Technical Response for Congressional Quiet Skies Caucus Staffers

Re: FAA's Report to Congress\*:  
DNL Metric and DNL 65 Standard  
For Airplane Noise

(\*The report submitted by the FAA in response to the Reauthorization Act of 2018, Sections 173 and 188)

**FAA’s “Equivalent Operations for DNL = 65<sup>8</sup>” Chart Illustrates DNL problems.**

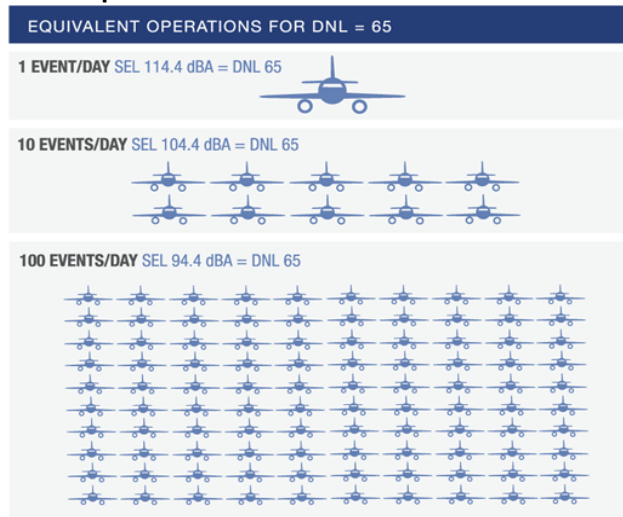
The DNL metric implies that there is **no meaningful difference** whether people are exposed to a few (1-10) aircraft noise events a day or hundreds of aircraft noise events a day. It describes the impacts of **dramatically different noise environments as equals, all examples are DNL=65.**

The three noise levels in FAA’s chart are not representative of communities that are suffering from NextGen. The noise levels portrayed occur at locations close to airports which have always had significant noise.

The chart fails to show the number of aircraft that would be required to reach the 65 DNL standard, in the now common scenario of communities with substantive noise complaints caused by NextGen implementations. If the FAA added this scenario to the chart, it would show that 1,000 planes per day are required to reach the DNL 65 standard to trigger a “Significant Impact”. (See next page for the graphic.)

## A Needed Addition to the FAA 's DNL = 65 Chart

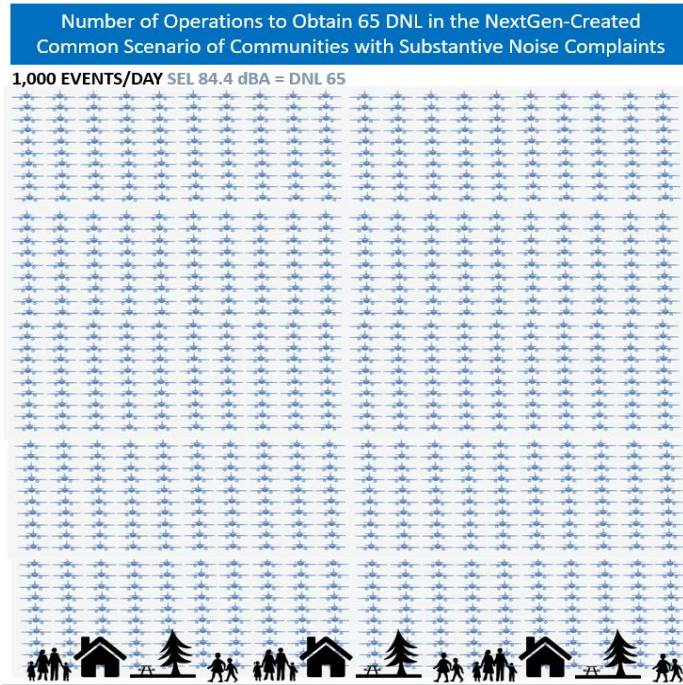
NextGen drastically increased aircraft concentration, and noise over some communities prior to when NextGen was rolled out. This noise concentration problem of NextGen was recognized in 2016 by then-FAA Administrator Huerta, who stated that, “more precise navigation paths ...have the effect of concentrating noise over a smaller area under the flight path.”<sup>9</sup>
